COUNCIL ASSESSMENT REPORT

Panel Reference	PPSEC-130
DA Number	DA-2021/95
LGA	Bayside Council
Proposed Development	Integrated Development - Demolition of existing structures and construction of a part 2 and part 3 storey residential aged care facility comprising of 113 rooms (116 beds), basement level parking, front fencing and signage
Street Address	119 Barton Street, Monterey
Applicant/Owner	Monterey Equity Pty Ltd / Monterey Equity Pty Ltd
Date of DA lodgement	15 March 2021
Total number of Submissions	• 13 + 1 petition
Number of Unique Objections	• 14
Recommendation	Refusal
Regional Development Criteria (Schedule 7 of the SEPP (State and Regional Development) 2011	General development with a capital investment value over \$30 Million
List of all relevant s4.15(1)(a) matters	• State Environmental Planning Policy (State and Regional Development) 2011 • State Environmental Planning Policy (Housing for seniors and people with a disability) 2004 • State Environmental Planning Policy (Housing) 2021 • State Environmental Planning Policy No. 55 (Remediation of Land) • State Environmental Planning Policy No. 64 (Advertising and Signage) • Rockdale Local Environmental Plan 2013 • Bayside L

Figure 6 - view of Barton Street properties (No's 115, 113, 111) with proposed facility beyond.

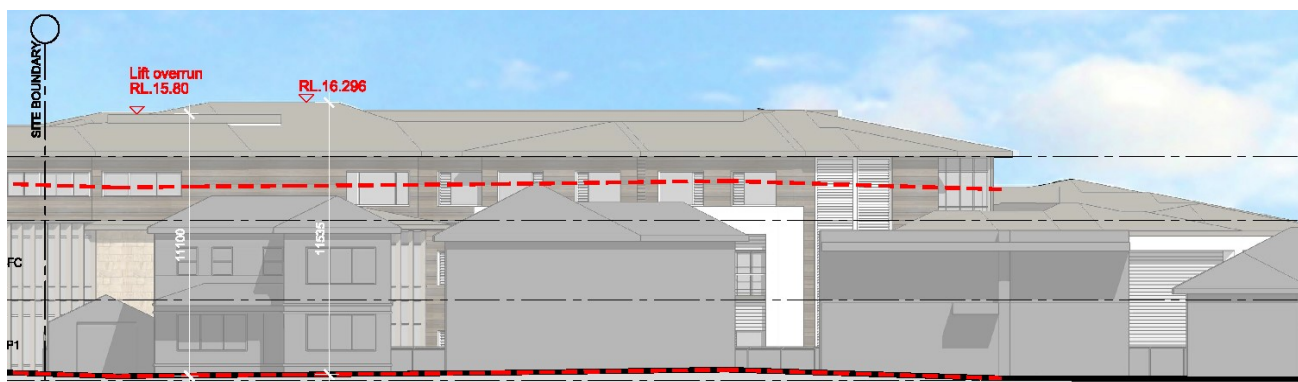
Comment: The proposal is for a part two and part three storey building which exceeds the maximum height by 1.975m (24.68%) under the Seniors Living SEPP and 4.096m (48.2%) under the Rockdale LEP 2011. The proposal will be visible from the street (**Figure 6**) and will appear dominant when viewed from the rear yards of surrounding properties. The subject site was recently zoned R3 Medium Density Residential with a height limit of 8.5m, however the proposal is part three storey and is considered out of context with both the existing and desired future context of the area.

While some amendments have been made to the scheme since this time, the Design Review Panel's comments are still generally applicable. The applicant has not undertaken genuine consideration of alternative site layouts and the proposed development will result in adverse visual bulk, scale and privacy impacts to surrounding residents.

Figure 8 - *Extent of building above 8m to the underside of the ceiling (as measured by Seniors Living SEPP). The proposal includes a roof above which extends up to 12.6m in height.*

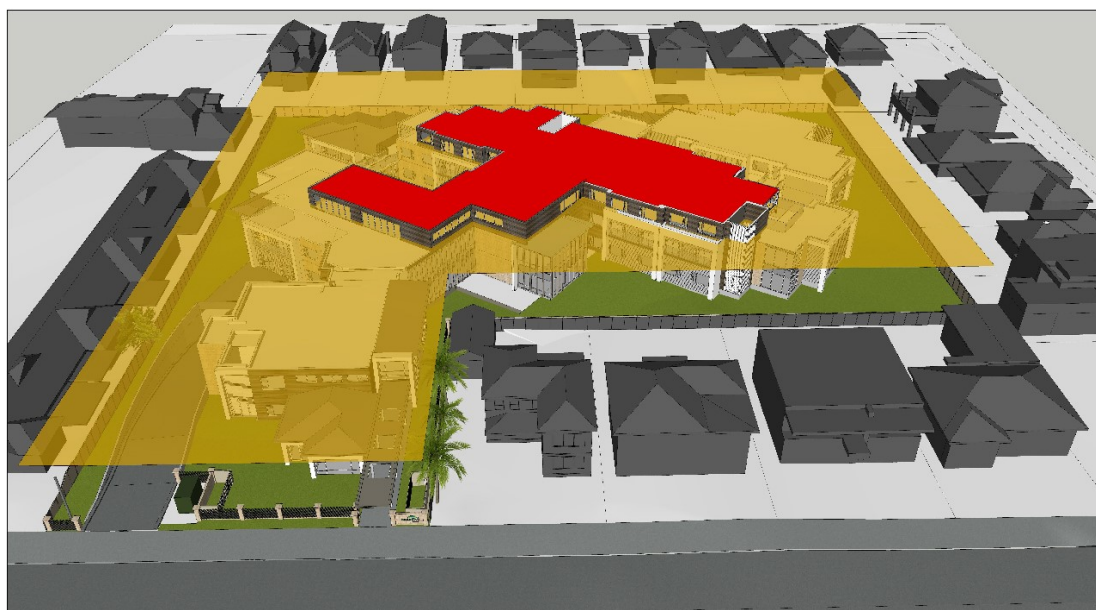
The Applicant finds that the three storey element is located 6.17m from No. 109 Barton St, 19.5m from the sites southern boundary, 21.2m from the sites western boundary and 15.4m from the sites eastern boundary.

* Height of 12.6m under the RLEP 2011 (48.2% or 4.096m variation) measured to highest point on the roof.

The site and adjoining properties are zone R3 Medium Density Housing zone. Developments are restricted to a maximum of 8.5m and 2 storey in height. The proposed three (3) storey built form is located a minimum of approximately 6m from No.109 Barton Street and No. 115 Barton Street, and nearby No.111 Barton Street. As shown in Figures 2 & 6 it is evident that the proposed three storey portion of the development is of an inappropriate scale that will result in adverse visual bulk to neighbouring properties. Figure 2 has been copied below and shows that the proposed two storey built form is appropriate for the existing and desired 8.5m / 2 storey building height context of surrounding sites.

Figure 7 - Proposed 2.1m barrier to minimise noise impacts to villas at No. 121 Barton Street.

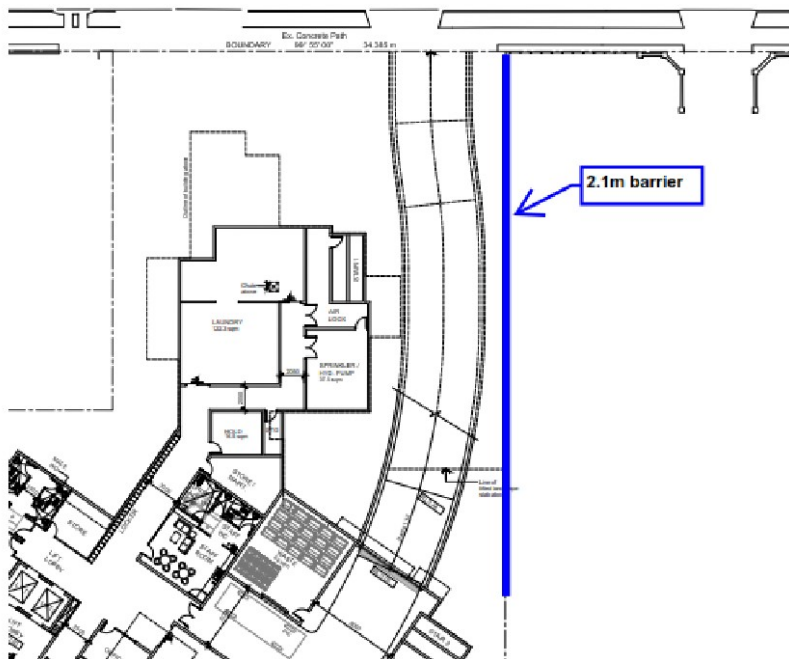
acoustic impacts from the proposed facility will be minimised and in accordance with the EPA Noise Policy for Industry 2017.

The proposed 2.1m barrier to minimise noise impacts from the vehicle access ramp to the site (which can accommodate MRV size trucks).
